Town of Orangeville

Infrastructure Services

Report No. INS-2020-013

Falkner Street - Sunset Drive 1.8 metre Curb Face Proposed Sidewalk

Enclosed – Falkner Street-Sunset Drive Sidewalk Location Plan

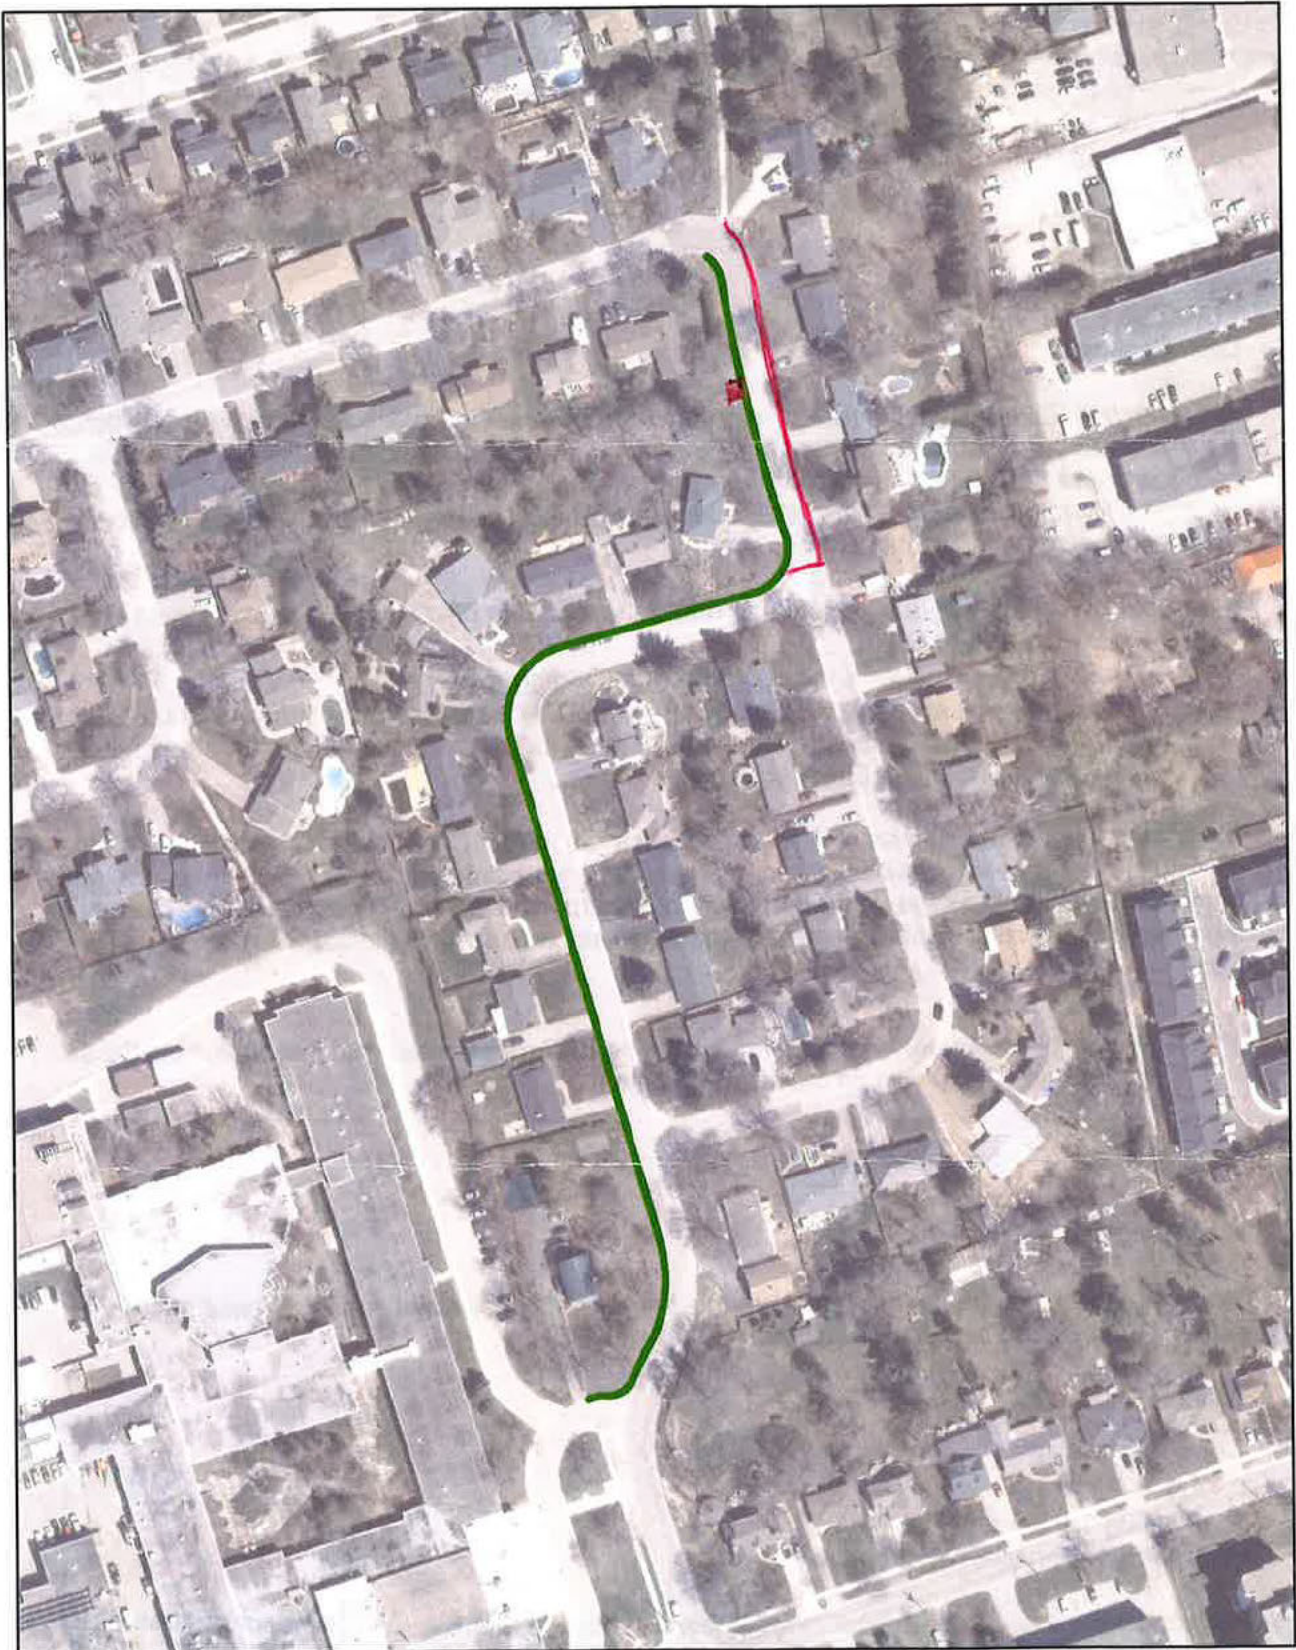
The Safety of the residents and students from O.D.S.S. and Princess Elizabeth School should be the primary concern.

The amount of bends and changes in elevation on bends (on Sunset especially) are dangerous when walking on the road. Especially in the winter when there are snowbanks.

I don't like the idea of pedestrians crossing the street on the bend at Northgate and Forest Park to access the walkway.

I would rather see people cross from the west side of Sunset to the east side of Sunset and then be on the same side as the walkway between Northgate and Bredin Parkway. Plus that would make the large green electrical box on the west side of Sunset a non issue. (obstacle) Shown in red.

I think there should also be a sidewalk from the walkway at the back of O.D.S.S. to the walkway between Northgate and Bredin Parkway.

Report No. INS-2020-013

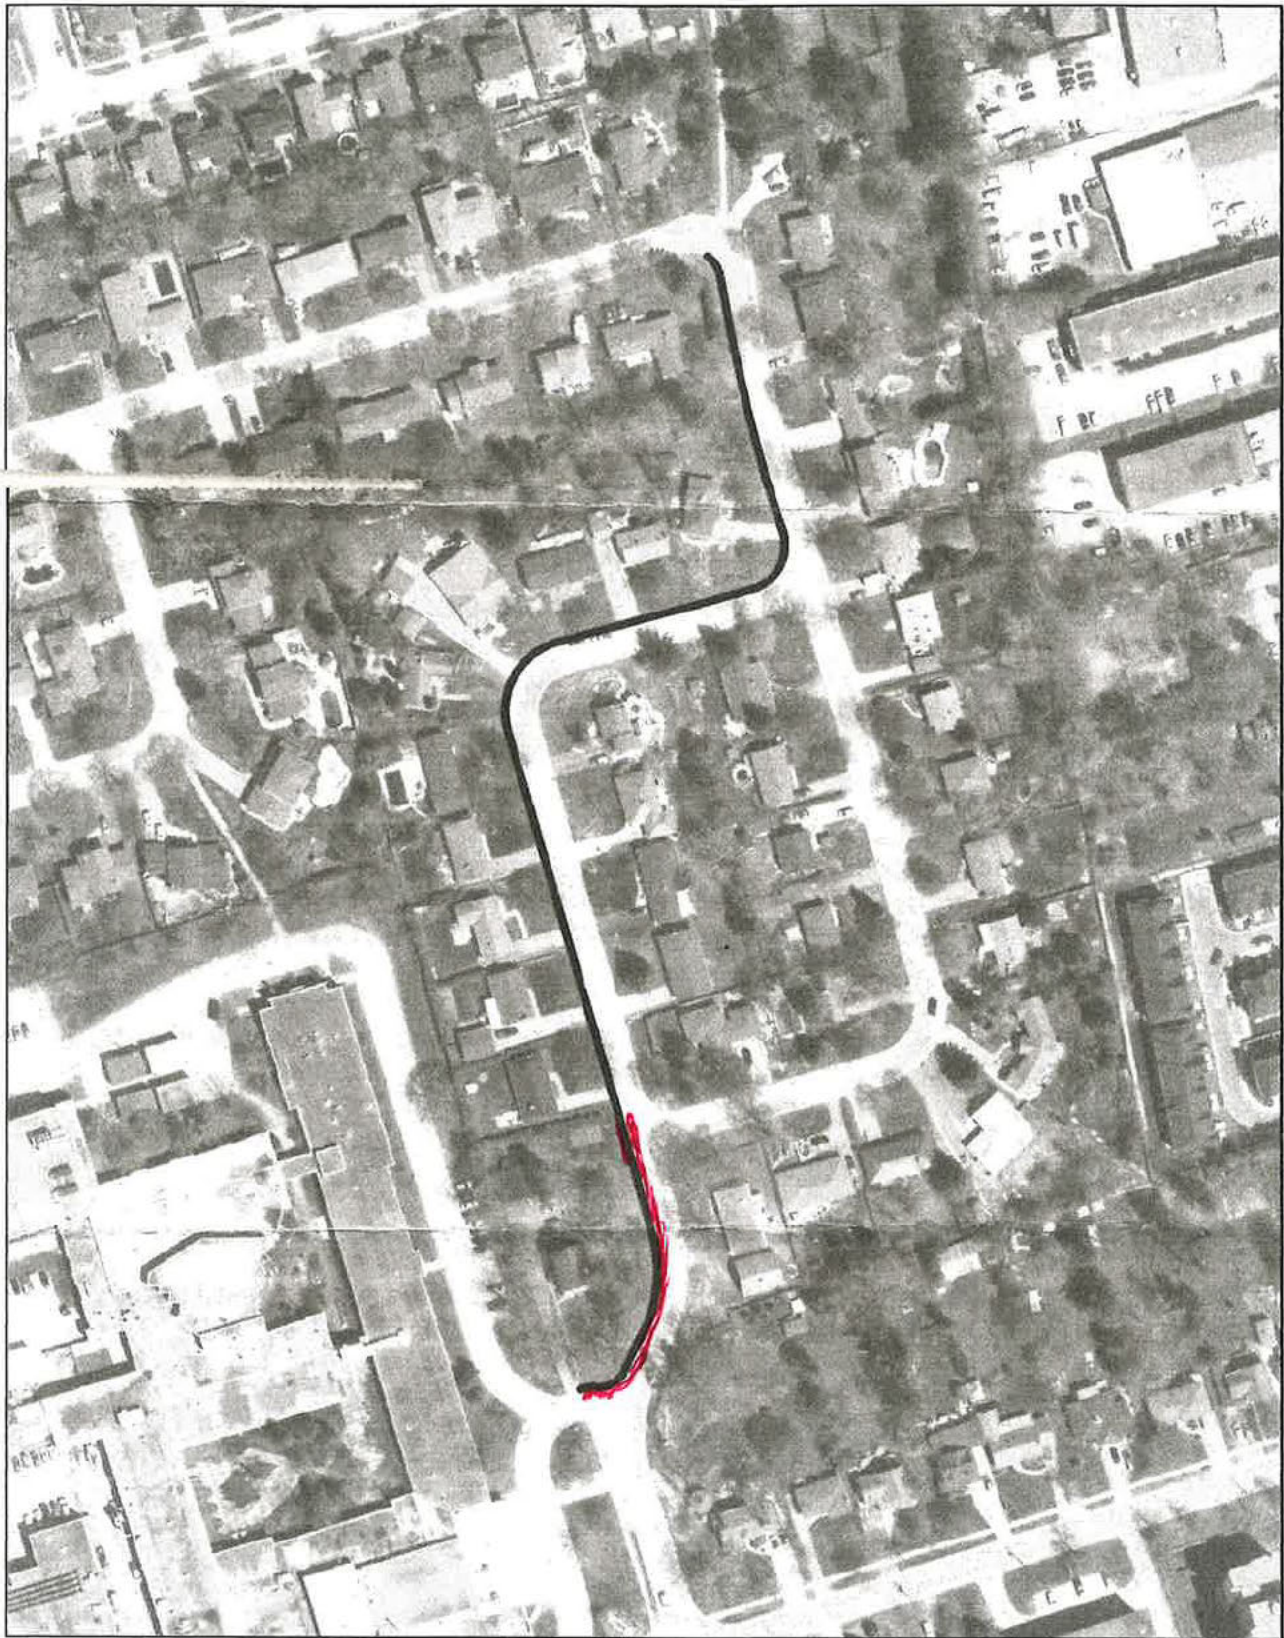
YES IT'S VERY DANGEROUS. PROLY NEEDED
AS SHOWN IN REG ON ATTACHED MAP, BUT NOT
NEEDED OR WANTED
BEYOND THAT.
